STAFF REPORT

CASE NUMBER: P.D. 07-344 CC **L.U.C.B. MEETING:** January 10, 2007

DEVELOPMENT NAME: Shelby Park East Planned Development

REQUEST: A mixed used planned development consisting of 48 single family residential lots (minimum lot size = $\pm 3,500$ sq.ft.) in Area A and two common open space lots in Area A and commercial uses in Area B.

PROPOSED SITE PLAN

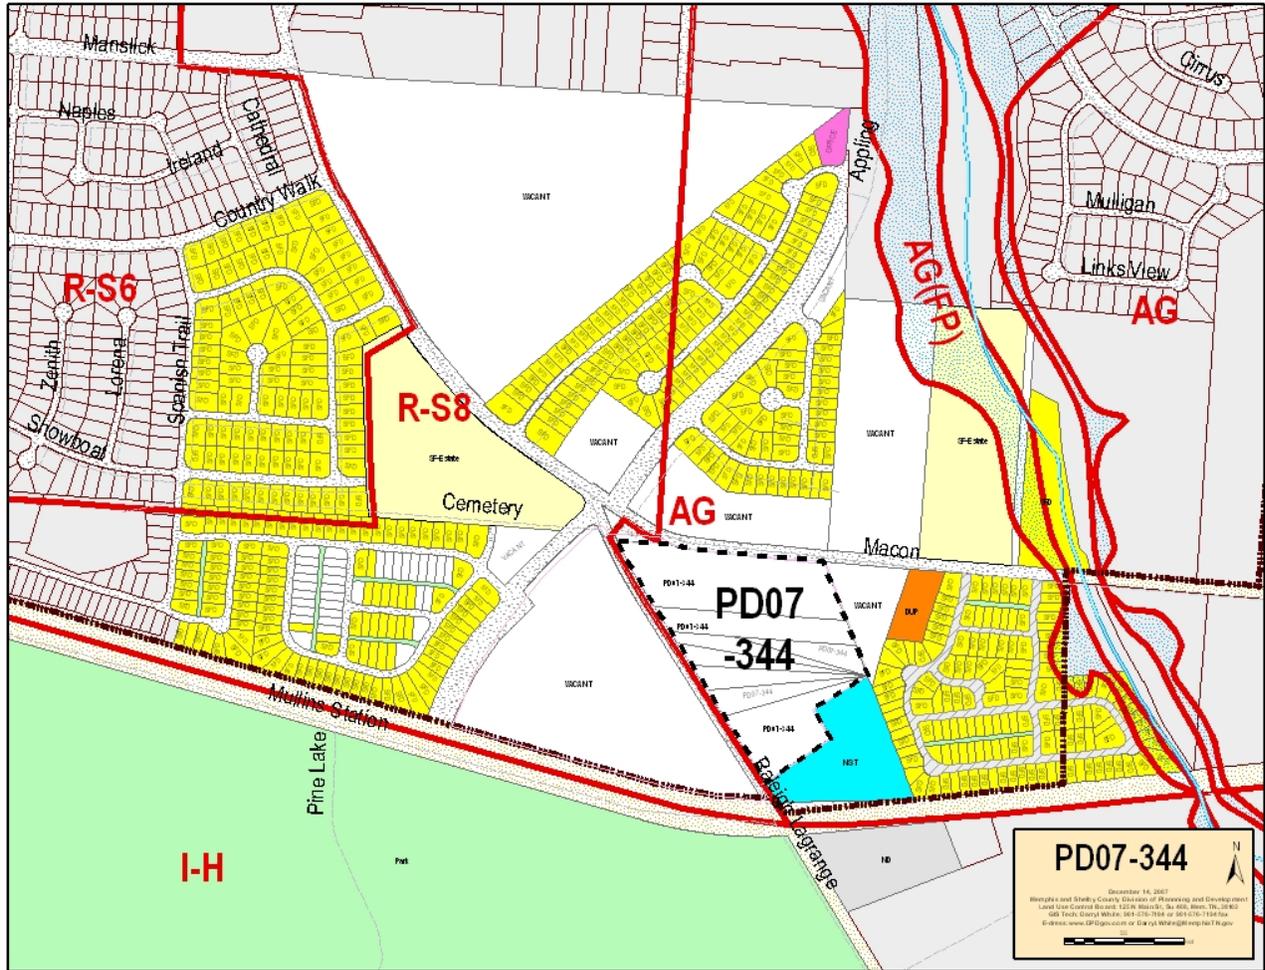
The first and most important issue of this development is that the site plan proposes the use of private drives (27 feet wide). The use of private drives within a small lot development is not desirable. Small lots on private drives will not have sidewalks for safe pedestrian access. Also, the site plan does not clearly show or label how the closure area of Raleigh-Lagrange Road will be incorporated within this development. Although the applicant has indicated that this area will become an alley, it is not clear if this alley will provide primary or secondary vehicle access for the adjacent lots or to the commercial development along Macon Road. It is recommended that a public road is needed to between the commercial portion of the development and the residential portion to aid in the safe and efficient circulation of traffic between these two uses. The private drives shown on the site plan are not acceptable to provide this function. The internal road system should be public and be redesigned to provide a consistent and pleasing streetscape screen along both sides to add to the appearance of this development.

The second item of concern is the proposed 20 foot front yard setback along the newly proposed private drives as shown on the site plan is not acceptable. A 27 foot front yard setback is standard requirement for lots that will have front facing garages to ensure adequate room is provided for the parking of cars in the driveways. Otherwise, lots with a 20 foot front yard setback should be wide enough to accommodate side load garages. Prior experience has shown that 40 foot wide lots cannot comply with this requirement.

Standard policy also requires that lots that are less than 50 feet in width be created with a rear service drive to provide driveway access to the lots. This design requirements leaves the front yard available to meet the requirements of the Tree Ordinance. A 40 foot wide lot as shown on the site plan cannot provide adequate accommodation for a driveway, garage or carport, and the installation of one Tree A in the front yard. Prior experience has shown that a 40 foot wide lot is not adequate to accommodate the sheer mass of the Tree "A" as it grows. A redesign to increase the lot widths of this development will provide the necessary additional space needed on each lot to comply with development requirements.

The next item of concern is the design and layout of the proposed 50 foot wide flag stem for the lot with the existing house, Lot 48, that would provide access to Macon Road for this lot. The applicant has indicated that the Church is planning to purchase proposed Lot 48 in order to obtain access and frontage to Macon Road for both the Church and the existing single family home. However, since the sale and consolidation of this lot with church lot may not happen for some time, the lot must be able to stand alone and meet all subdivision requirements. The configuration of this flag staff and the presence of a private drive over the first 190 feet of the area from Macon Road is problematic. As shown on the site plan, the frontage for proposed Lot 48 will be via a private dead-end road. The creation of lots at the end of road cannot be permitted for this lot as well as two additional lots proposed within the development, Lots 17 and 27. This area needs to be redesign to create a better means of providing both road frontage and access to this large lot.

A last item of concern pertains to the lack of a any proposed detention pond area in Area B separate from Area A and any proposed landscaping shown on the concept/site plan. Although details of proposed building placement and parking are shown on the concept/site plan, no information or details concerning proposed detention or landscaping is shown for consideration as part of this development. The County Engineering Office indicates that the placement of separate detention areas in both the residential and commercial portions of this development is very important and should be shown on the site plan. Also, the inclusion of landscaping on the site plan is not only important for aesthetic purposes but also to screen the newly proposed residential lots to the south. Especially, since the applicant is proposing to create a private drive to link the residential area to the commercial area, along its eastern boundary. Both staff and County Engineering agrees that additional information must be provided on this site plan concerning proposed drainage detention, landscaping, and circulation between this the commercial and residential areas should be provide with this proposed site plan.

- A. Dedicate 34 feet from centerline of Macon Road and improve in accordance with Subdivision Regulations.
- B. Street D shall intersect Macon Road at a ninety degree angle (approximately) rather than as shown on the proposed outline plan.
- C. There shall be a minimum of 250 feet of separation between Street D and the proposed curb opening to Macon Road from the commercial area.
- D. The City/County Engineer shall approve the design, number and location of curb cuts. Any existing nonconforming curb cuts shall be modified to meet current City/County Standards or closed with curb, gutter and sidewalk.
- E. Any curb cut along the Macon Road frontage beginning closer than 300 feet from the centerline of Appling Road will be limited to right in/right access only.

- F. A Common Open Space should be designated between Shelby Park PD, Phase 2 and the proposed Shelby Park East PD, along the existing Raleigh LaGrange Road closure and between lot 47 of Shelby Park PD, Phase 2 and lot 1 of the proposed residential. The intent of the Raleigh LaGrange Road closure is to provide a walking trail (COS) and not a driving lane connecting future commercial buildings with the proposed residential.

- G. Provide and show how the existing house (lot 48) will have access to a public street.
- H. Properly show the Raleigh LaGrange Road closure in front of the existing house, lot 27 and the beginning of public ROW and the existing hammerhead with existing turnaround easement.

- I. Lot 17 and 27 does not have adequate road frontage.
- J. All private drives are subject to review by County Engineer for compliance with Geometric Design Standards. All private drives shall be constructed to meet County standards and provide a minimum pavement width of 22 feet exclusive of curb and gutter.
